IAEWESTWIND

SERVICE BULLETIN

1124 SERVICE BULLETIN INDEX

FIGURE 1A

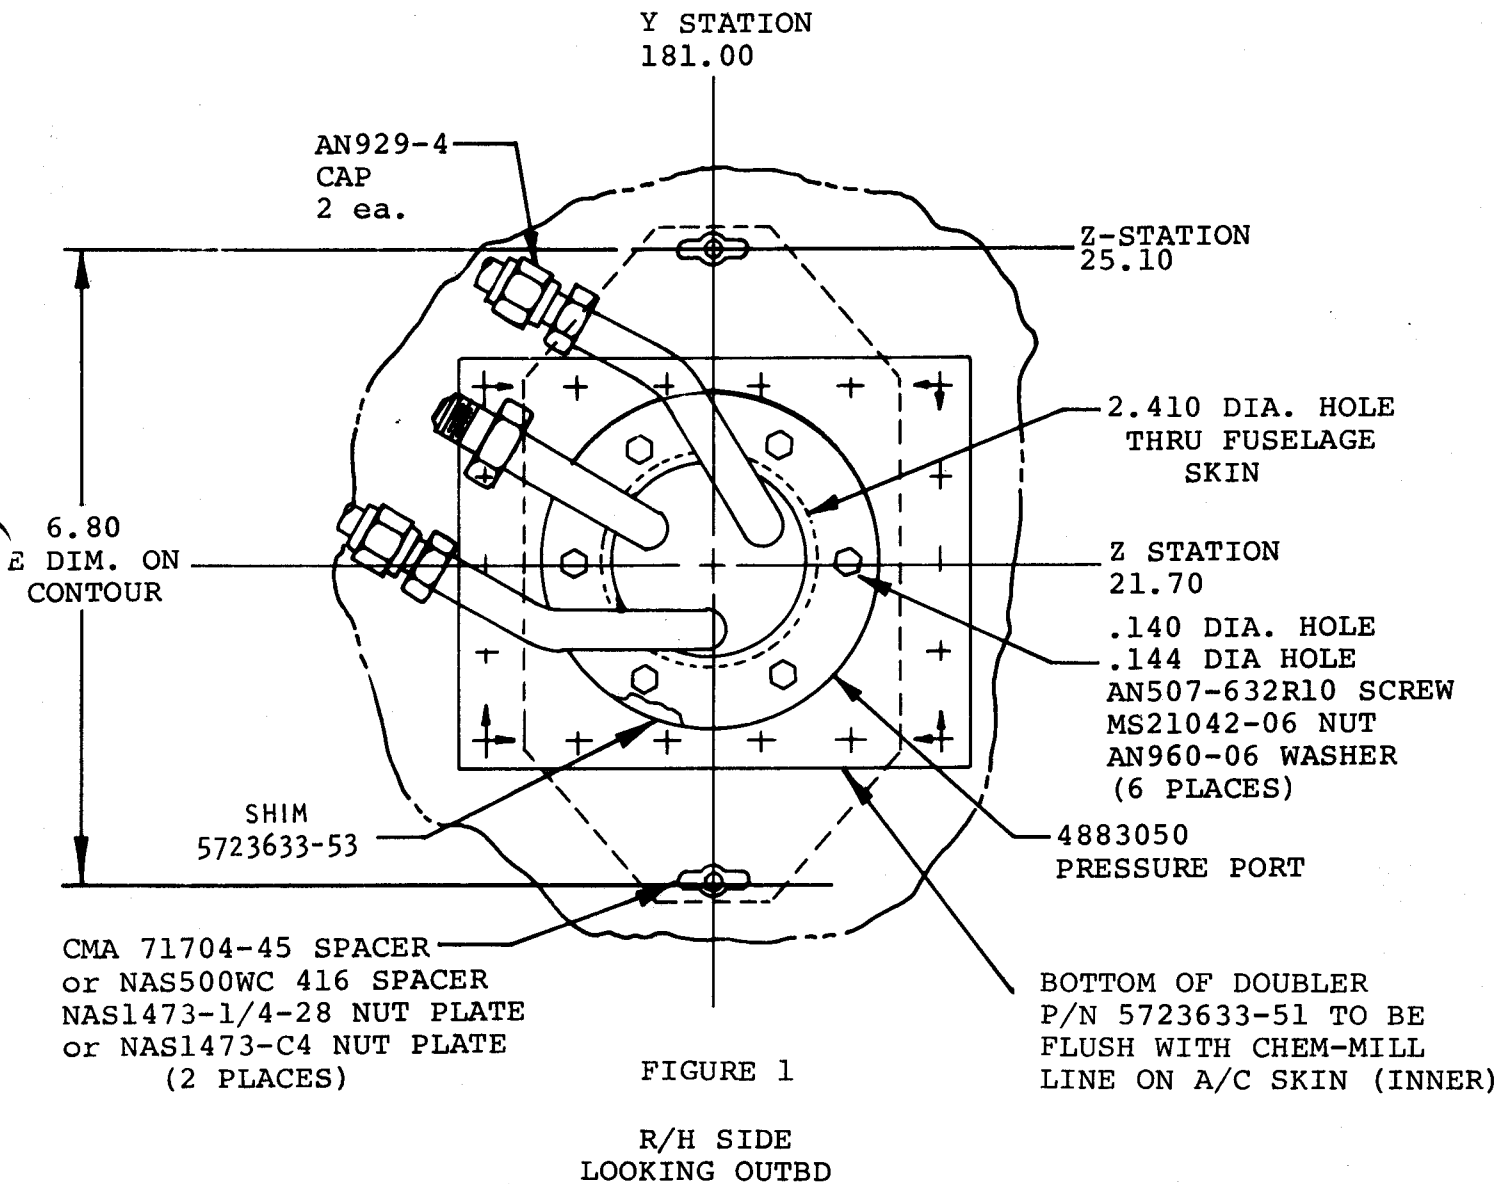
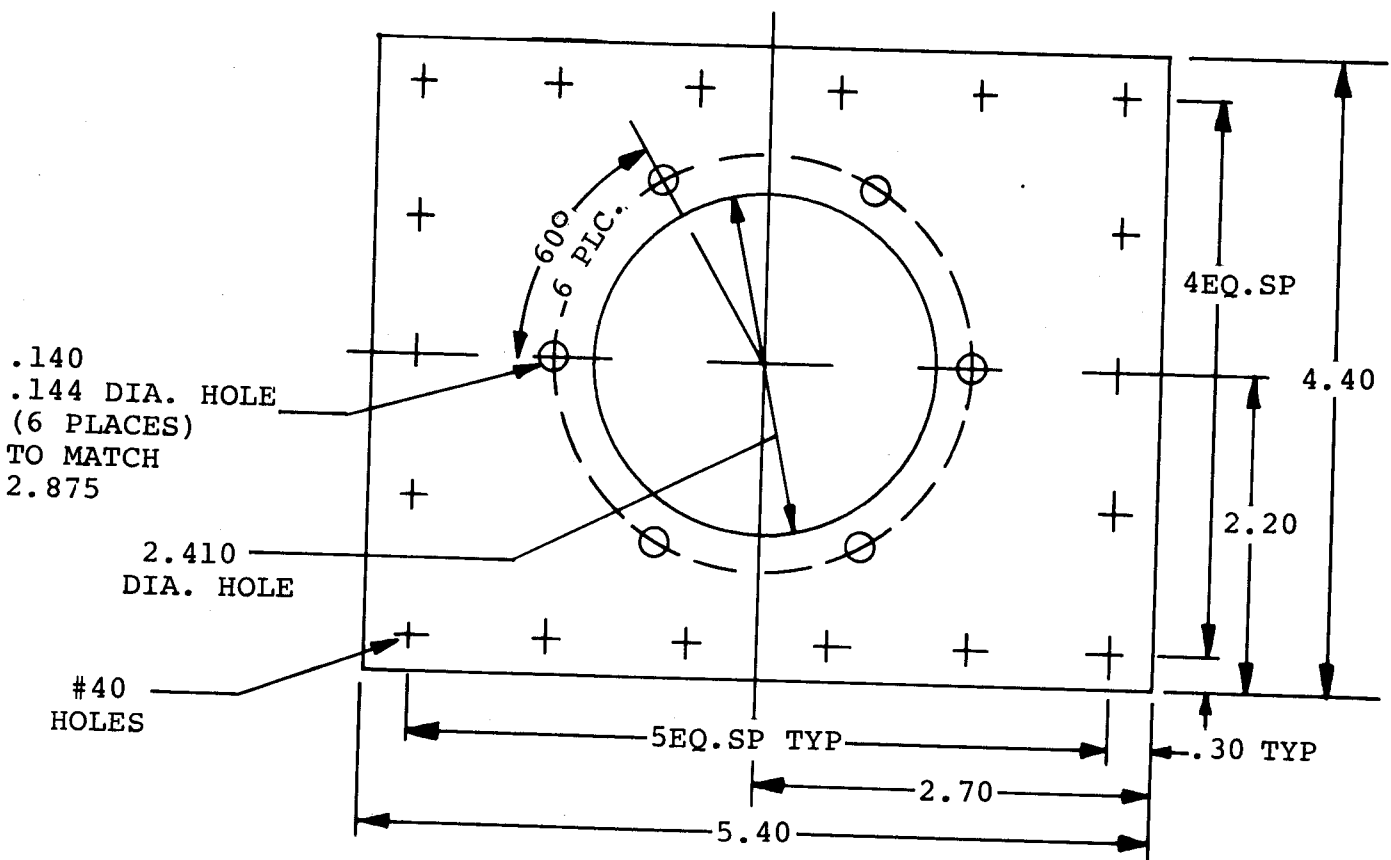
- (1) Remove soundproofing material below R/H emergency hatch, between frames Y-174 and Y-184.
- (2) Locate Y-Station 181 and mark, locate Z-Station 21.70 (water line) and mark. (Refer to Figure 1.)
- (3) Fabricate a doubler (P/N 5723633-51) from 2024-T3 clad .050 thick aluminum as per dimensions in Figure 1A. Etch doubler and treat with Alodine 1201, finish with epoxy primer.

- (4) Measure, mark and cut out hole in fuselage at Y-Station 181 and Z-Station 21.70 (R/H side). Use doubler fabricated above (item 3) as a template for rivet holes and static-port retaining screw holes location (Figure 1).
- (5) Drill .250 inch holes for static-port cover as per dimensions in Figure 1. Attach (2 each) nut-plates P/N NAS1473-1/4-28 and spacers P/N CMA71704-45 to inside fuselage skin.
- (6) Countersink rivet and screw holes for port and doubler from the outside of fuselage skin. Countersink .250 holes for static port cover (Figure 1).

FIGURE 1B

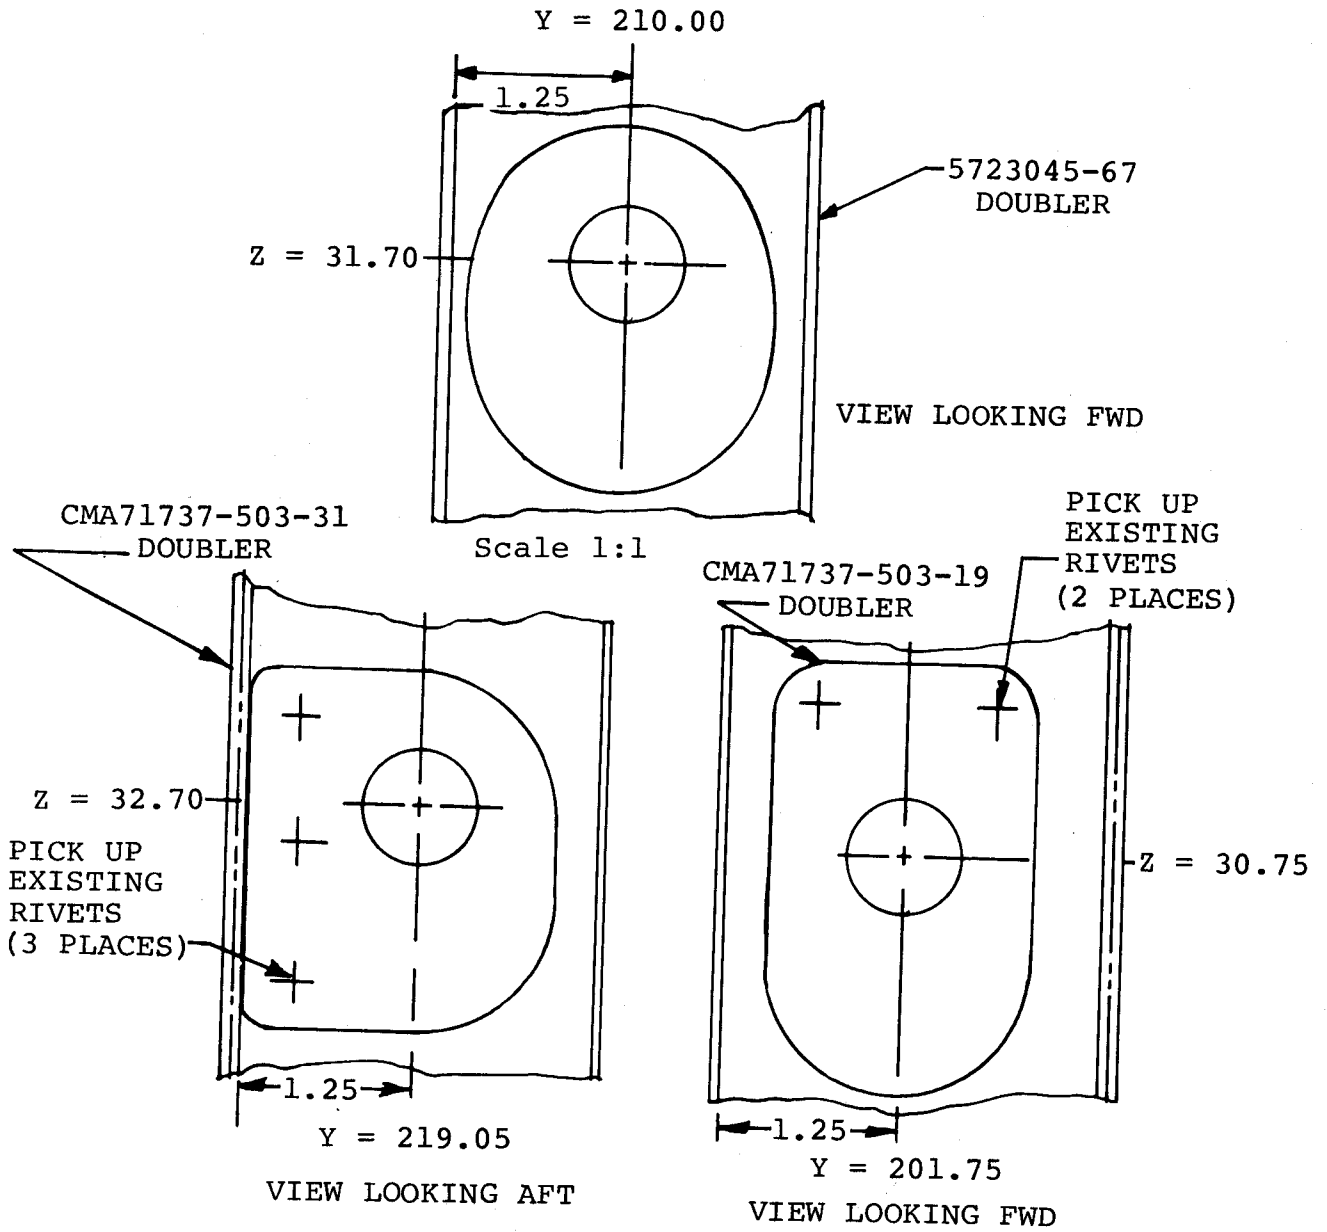
- (b) Doubler for frame 194 must be of sufficient length to cover the existing hole at Z-Station 28.20. (See Figure 1C.)
- (c) Install NAS1033-A3 nut-plate on aft side of frames 210.00 and 201.75 (Fig. 1B). (Same as L/H side.)

POWER SUPPLY INSTALLATION
FIGURE 1

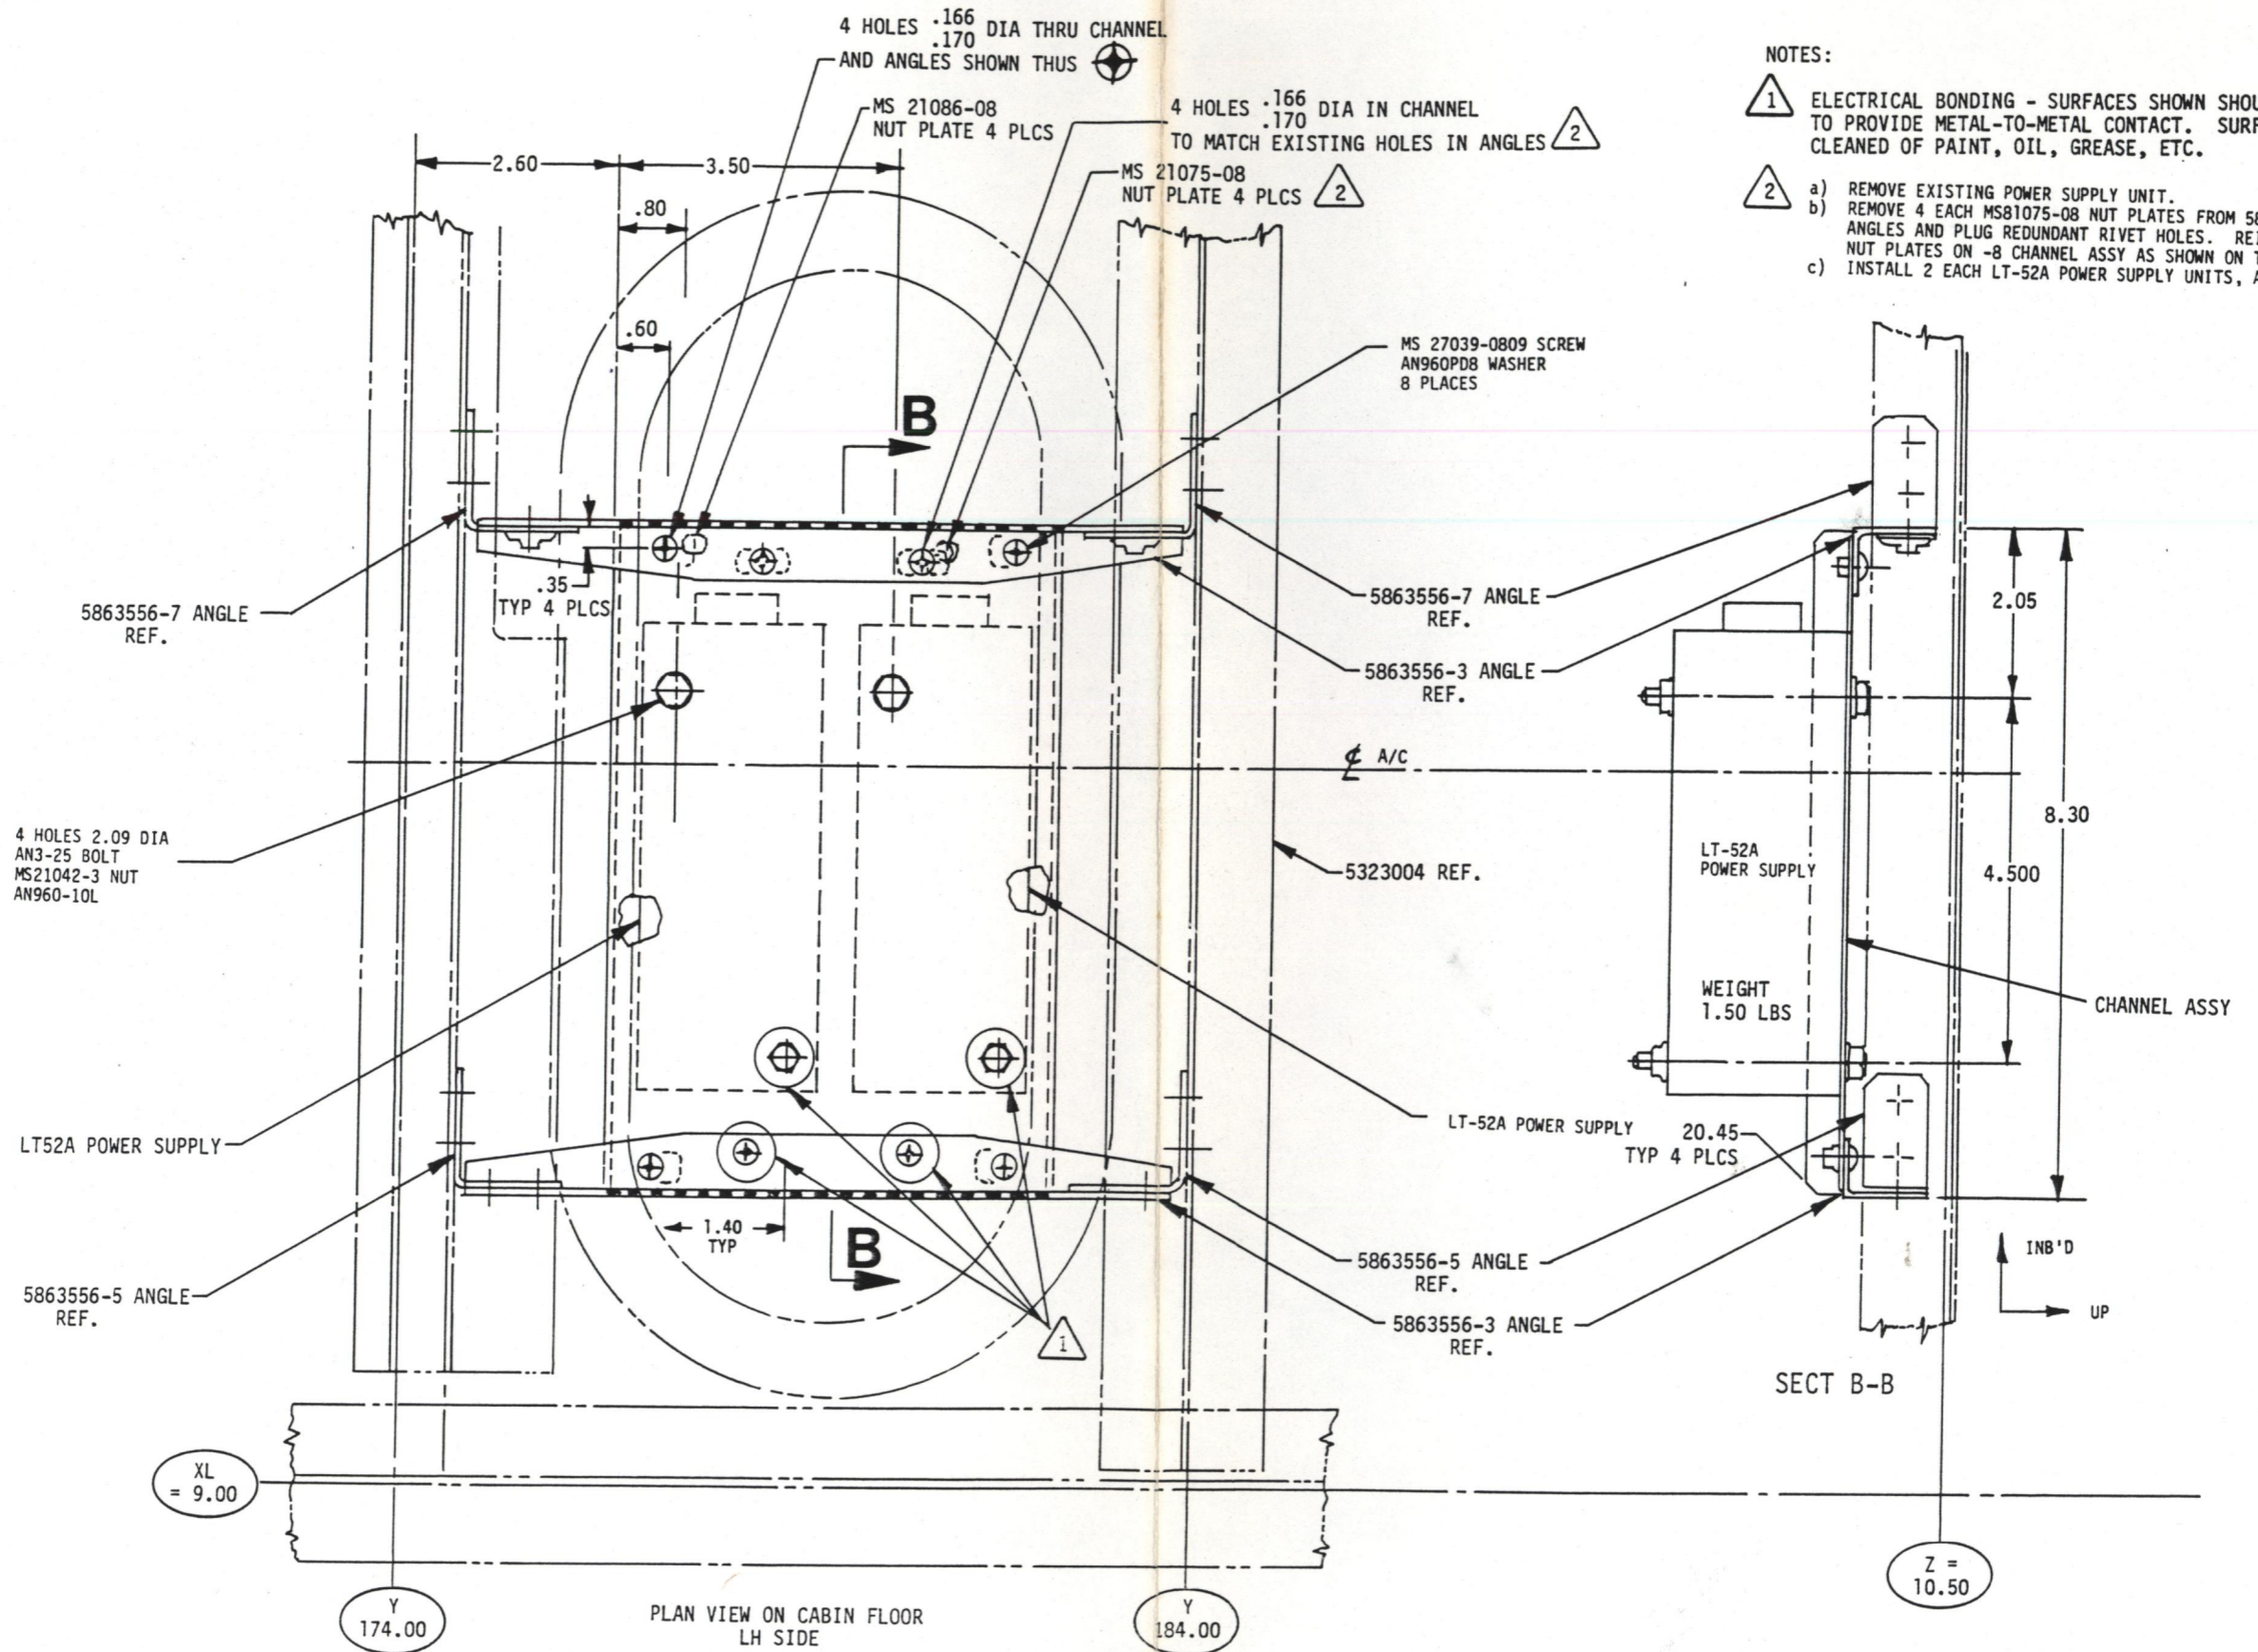
- (3) Modify existing mounting plate angles as shown in Figure #1 to accommodate installation of 2 each KGS LT-52A power supplies and new plate P/N 5863569-3. Install power supplies with AN3-25 bolts.

- (4) Install mount and power supplies to airframe using existing angles and hardware shown on Figure #1 to mount new plate. Label power supplies as B206 and B211 for reference and identification purposes.

FIGURE 1

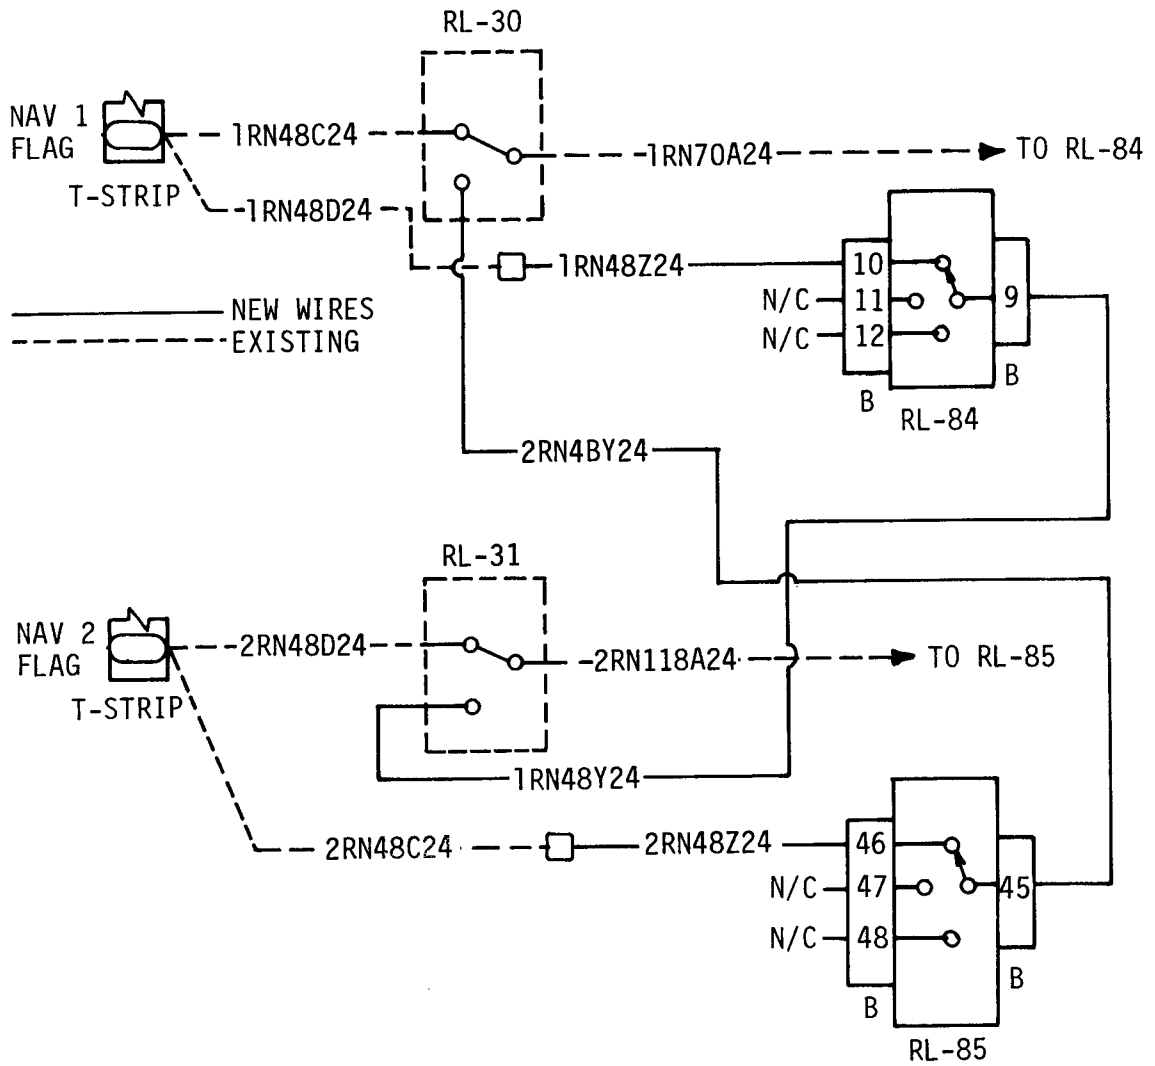
- B. Conformity with the above tests indicates compliance and no further action is required. Unsatisfactory results will require modification in accordance with the remaining steps (reference Figure 1).

FIGURE 2

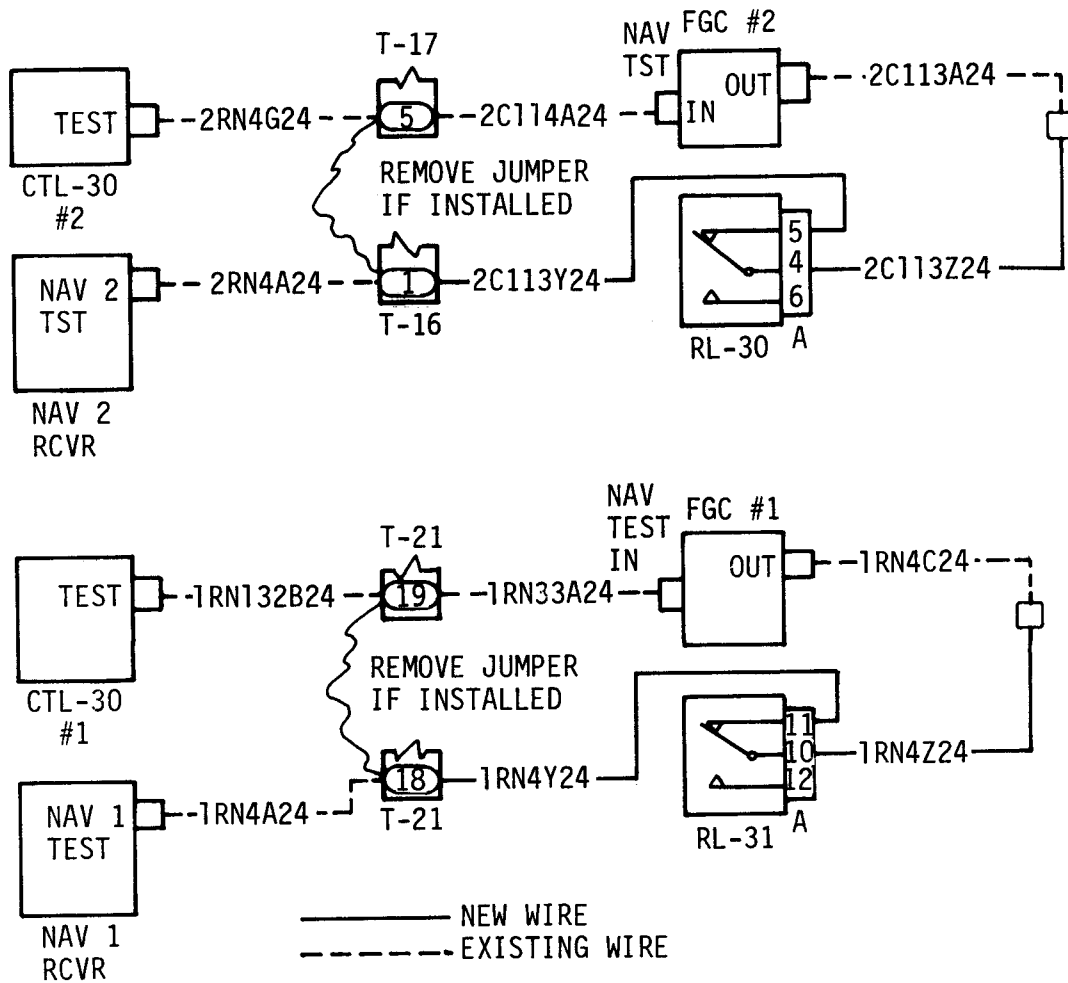
- (2) At copilot position, select "RPT NAV 1" and attempt VIR-30A self-test on #1 NAV CTL-30. Restore Copilot HSI to Normal VOR/LOC.
- B. Self-test in Step A must be inoperative, conformity indicates compliance and no further action is required. Should self-test be operational, modify in accordance with the following steps (reference Figure 2).
